APPENDIX A  
NOTICE OF PREPARATION  
AND INITIAL STUDY

## Subject: Notice of Preparation of a Draft Environmental Impact Report

**Project Title and Number:** La Costa Town Square EIR  
SCH# 2003041159

## OPTION 1: Desired Shelter Pad Dimension for a 13-foot Shelter

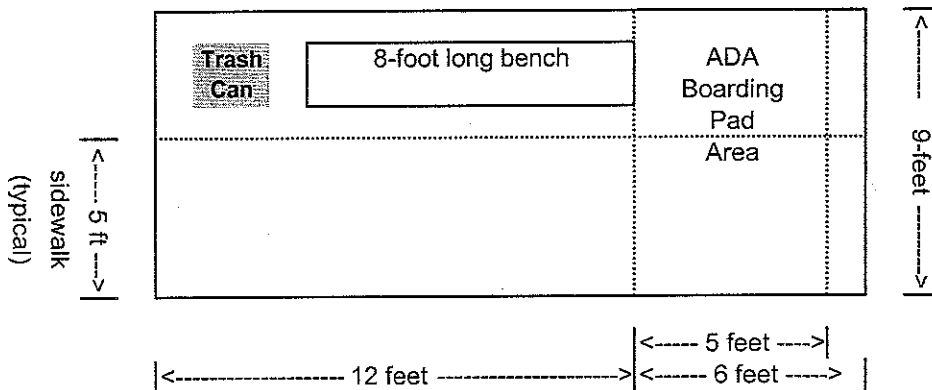
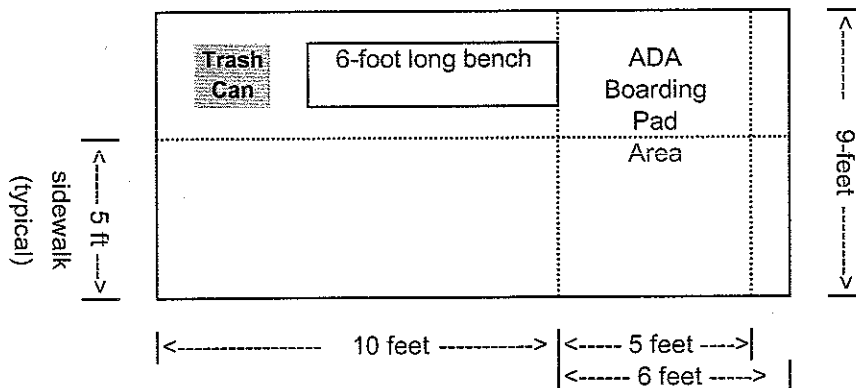
After reviewing the site design plan included in the NOP, NCTD requests that the developer make infrastructure improvements at several current and future bus stop locations that would serve this development. This request is made due to the likely number of transit passengers which will be generated from this type and size of development. These locations are at:

NOTE 1: The minimum pad depth (from face of curb) to be compliant with the Americans with Disabilities Act (1990) is 8-feet.

NOTE 2: No street furniture (benches, shelters, or trash cans) should be installed within 2 1/2 feet of the curb to avoid being hit by passing buses or trucks.

# BUS TURNOUTS

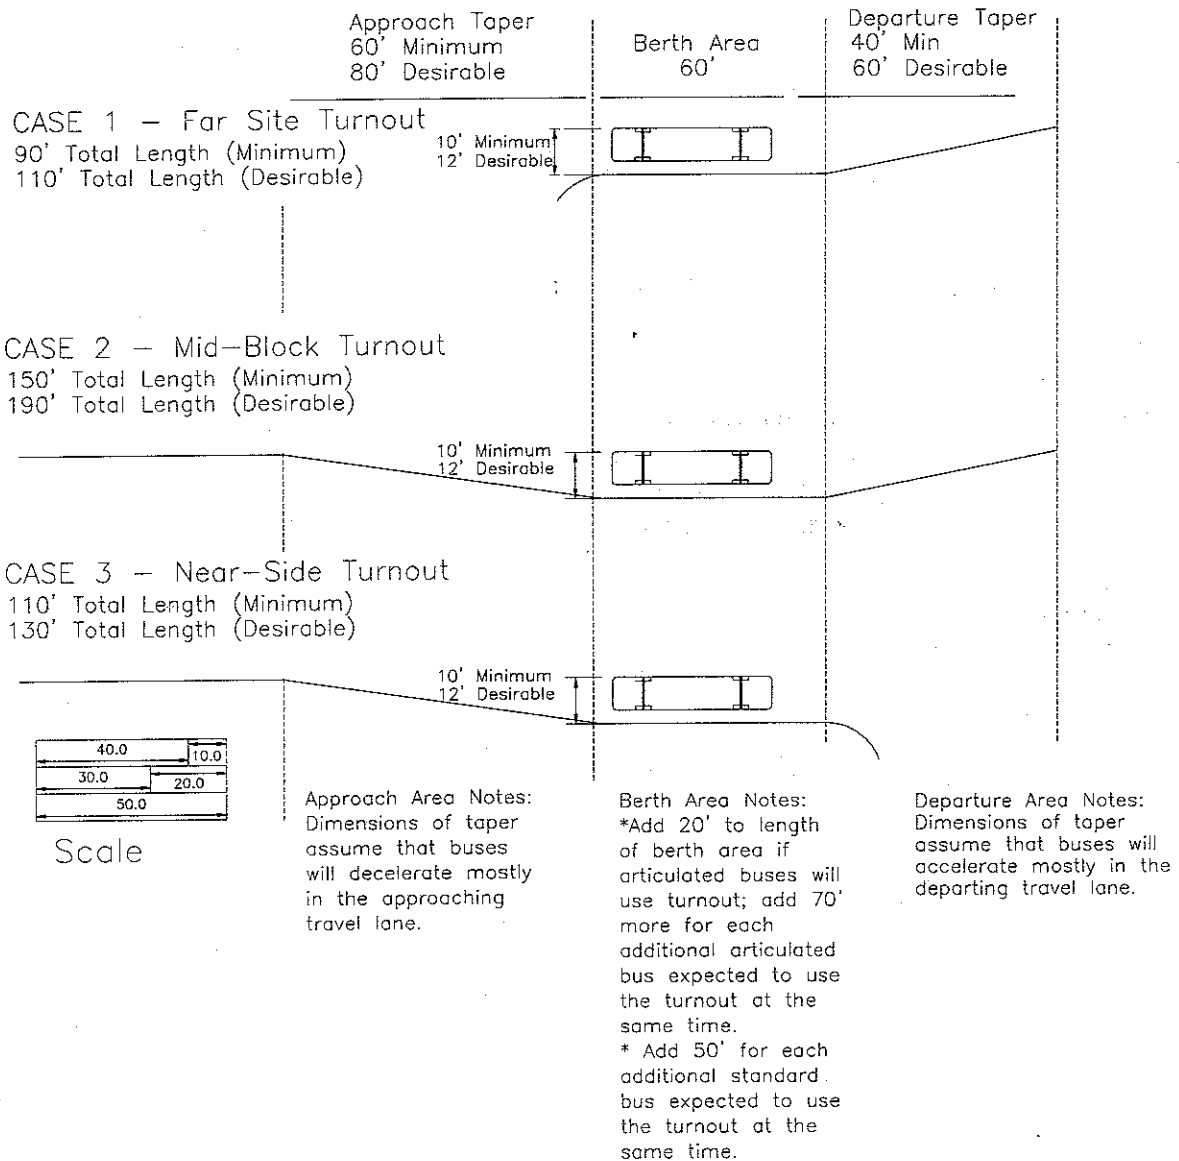
Bus turnouts are widened sections of roadway designed for buses to pull out of the traffic stream. In cases where there are no parking or right-turn lanes or where traffic speeds or passenger boardings/bus volumes are high, a bus turnout may be necessary. Bus turnouts should be considered at a location when the following factors are present:

- Traffic in the curb lane exceeds 250 vehicles during the peak hour,
- Traffic speed is greater than 40 mph,
- Bus volumes are 10 or more at peak hour period on the roadway,
- Passenger volumes exceed 25 boardings an hour,
- Potential for auto/bus conflict warrants separation of transit and passenger vehicles,
- History of repeated traffic and/or pedestrian accidents at stop location, and
- Sight distances (i.e., hills, curves) prevent traffic from stopping safely behind a stopped bus.

NCTD recommends that concrete bus pads be installed at all bus turnouts to reduce road maintenance (see Case III on page 11). This will reduce the amount of necessary street maintenance due to pavement damage at bus stops.
